KS23-001A
 ITB23-013A
 April 18, 2023

VOLUNTARY SAFETY RECALL CAMPAIGN 2022 QX50 AND 2023 QX55; RIGHT FRONT DOOR LOCK

CAMPAIGN ID #: PC962

Figure 1

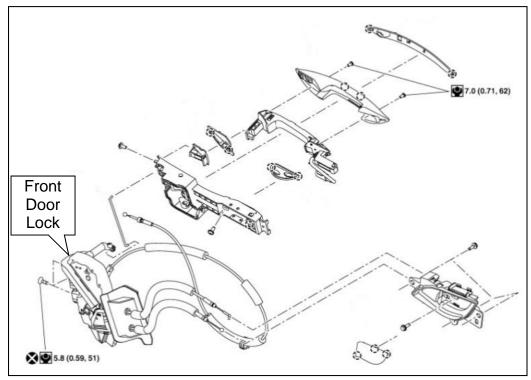
- 1. Replace the passenger (RH) Front Door Lock.
 - Refer to the ESM: BODY EXTERIOR, DOORS, ROOF & VEHICLE SECURITY > DOOR & LOCK > REMOVAL AND INSTALLATION > FRONT DOOR LOCK > DOOR LOCK
